Product Change Notification / RMES-11GYOB585

CCB 4854 Final Notice: Qualification of ATP7 as an additional assembly site for Microsemi PD69104xx and PD69108xx device families available in 48L VQFN (8x8x1.0mm) package.

CCB 4854
Pre and Post Change Summary
PCN #: RMES-11GYOB585

LEAD FRAME COMPARISON

NSEB

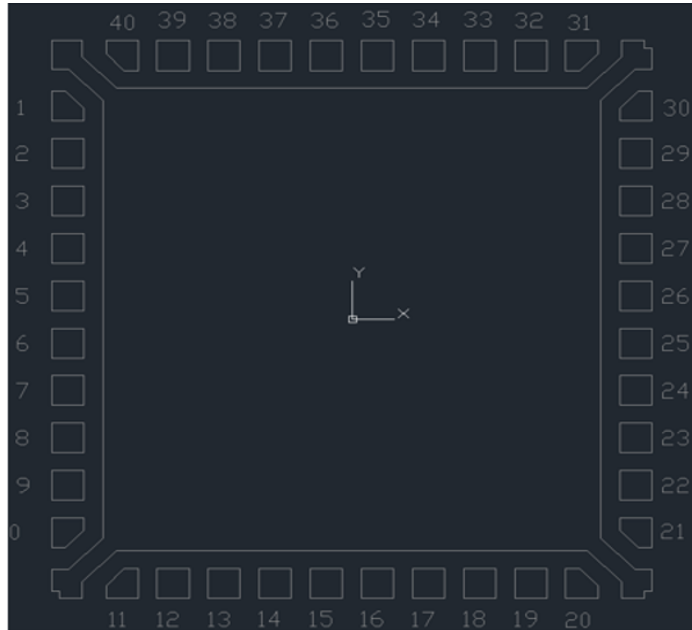
Lead Frame Material	EFTEC-64T
DAP Surface Prep	Spot Plating (Ag on lead only)

ATP7

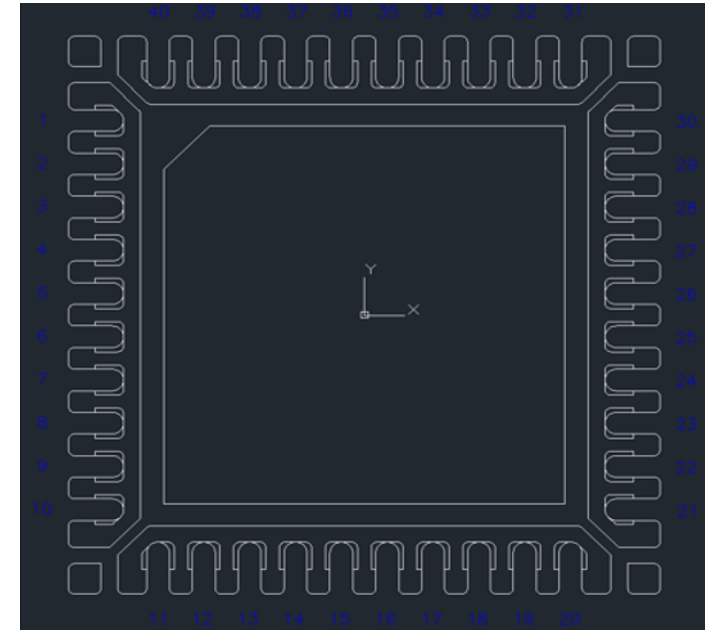
Lead Frame Material	C194 FH
DAP Surface Prep	Ring Plating
